SECTION 00 91 01

ADDENDUM NO. 1

BUILDINGS 5 & 6 RENOVATIONS
 San Mateo County Community College District

CAÑADA COLLEGE
 4200 Farm Hill Boulevard
 Redwood City, CA 94061

Drawing Number
A9.44R

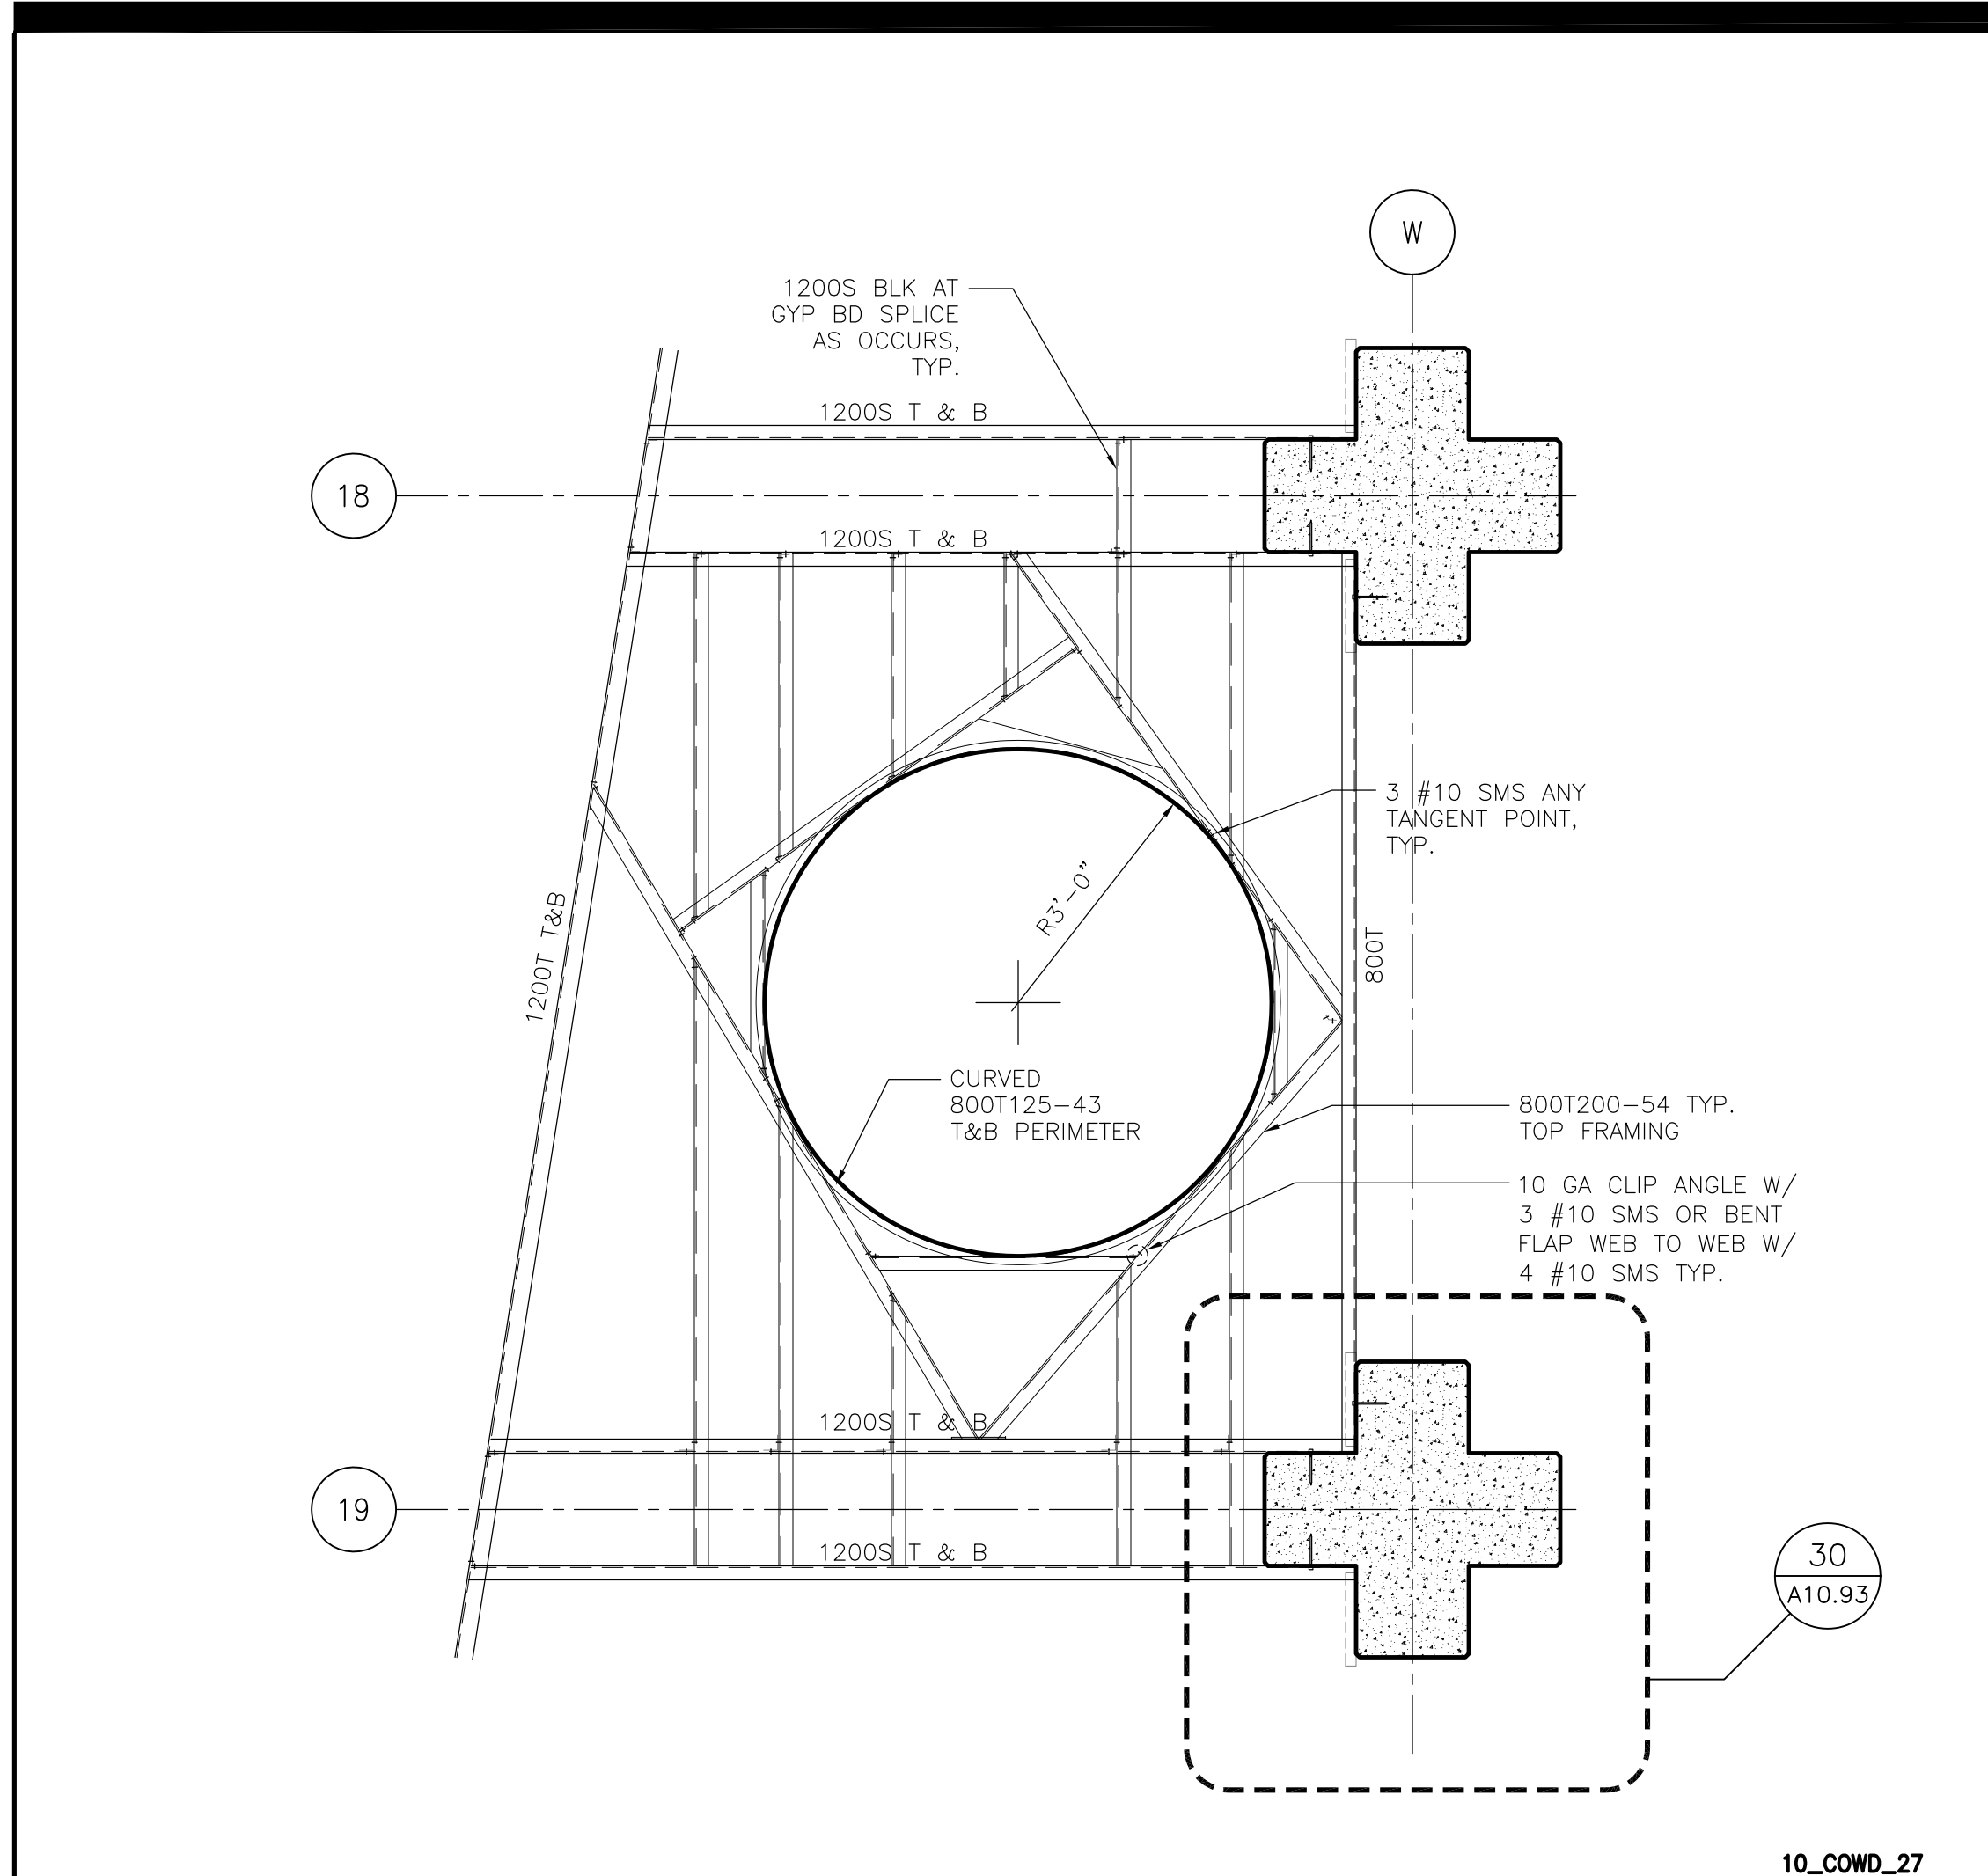
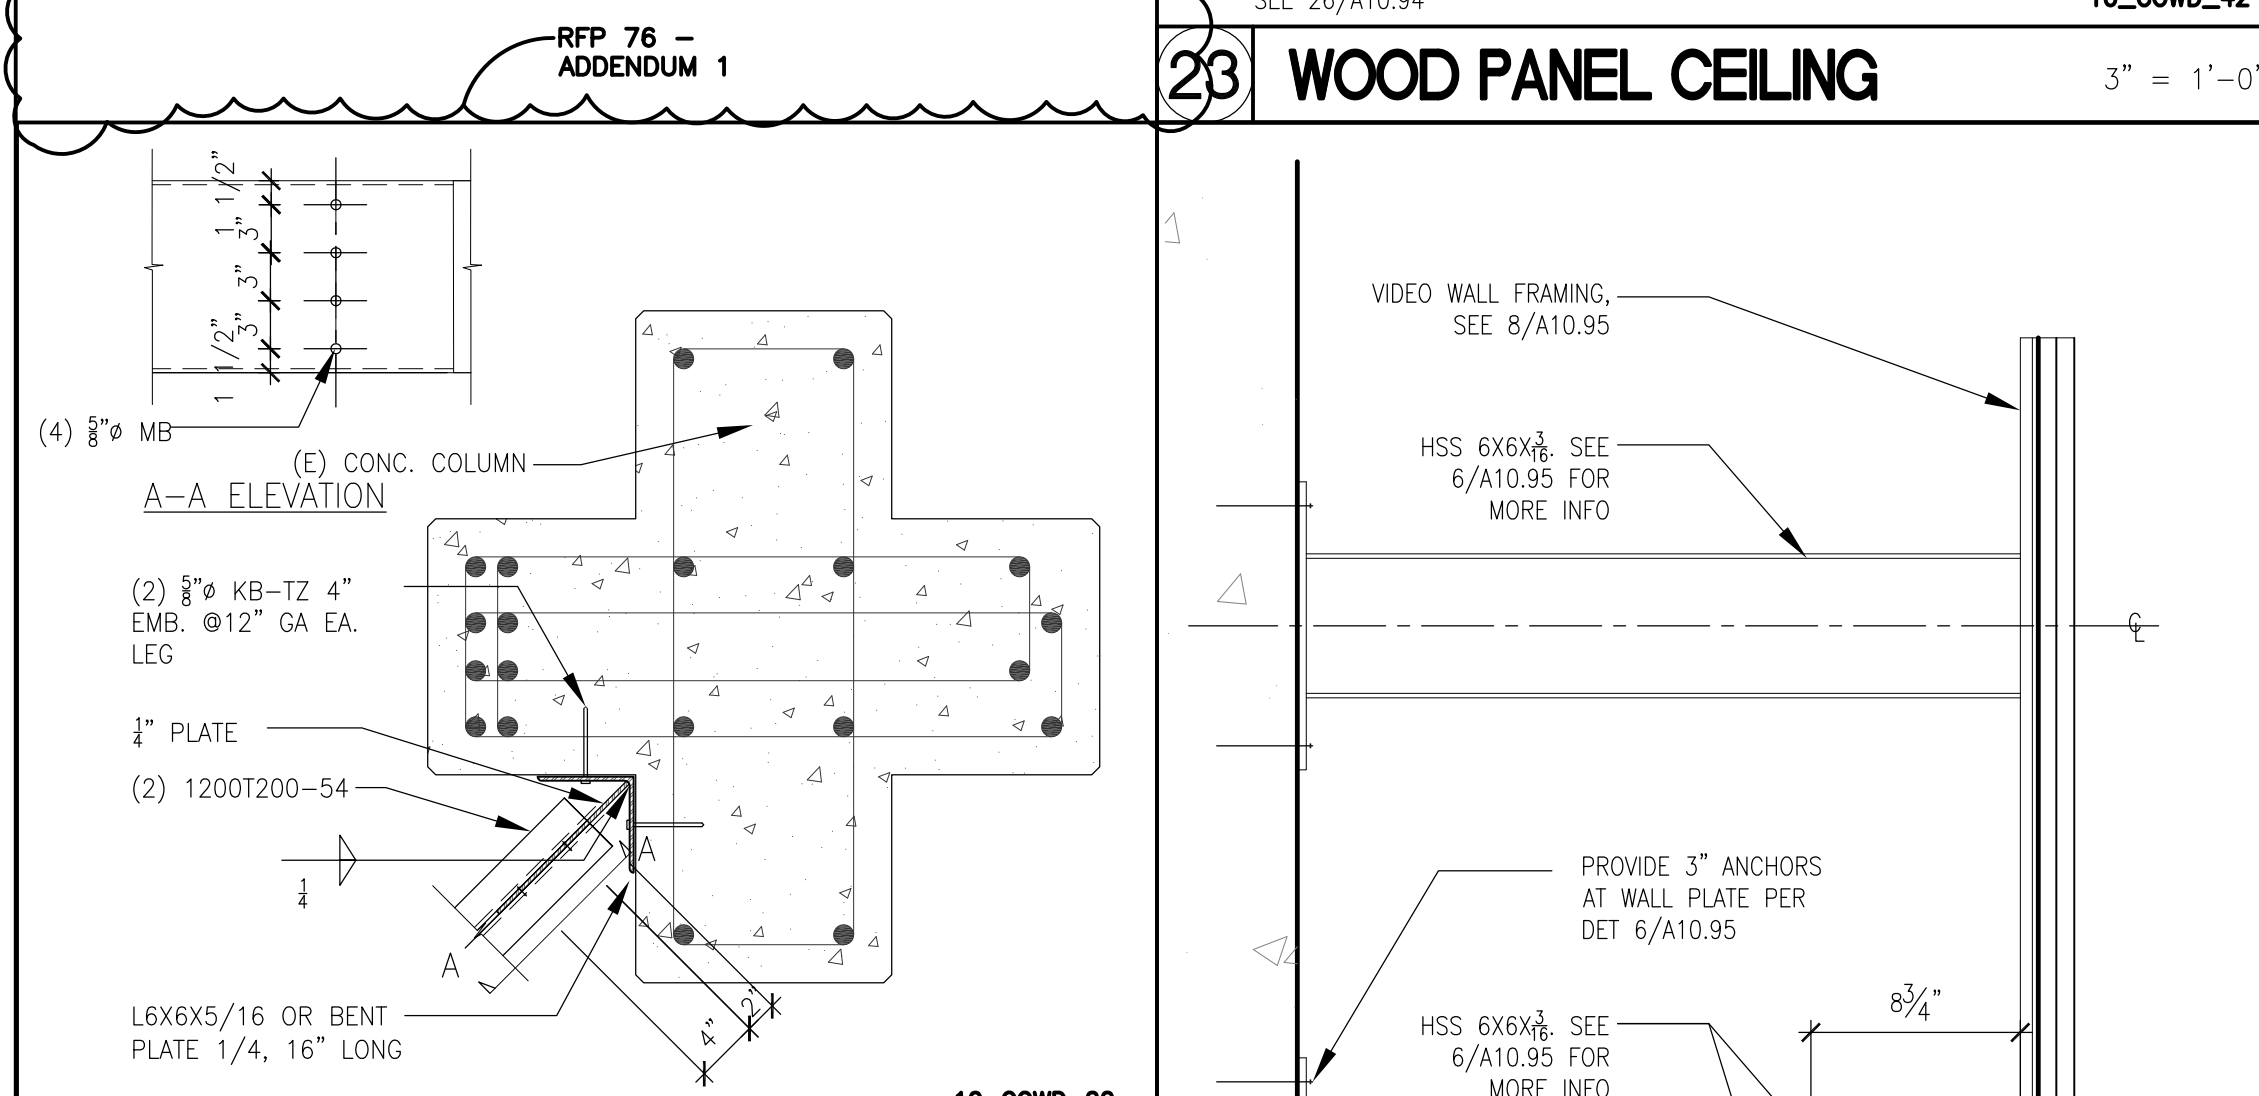
2. Revised Sheet Note 115.
8. Drawing A9.44R – Third Floor Finish and Signage Plan – Add Alternates.
 - A. Modified drawing as shown on attached revised Drawing A9.44R:

1. Revised Finish Legend and Third Floor Finish and Signage Plan.
 2. Revised Sheet Note 115.
9. Drawing A10.93R – Wall Types and Casework Details.
 - A. Deleted Detail 28, as shown on attached Drawing A10.93R.
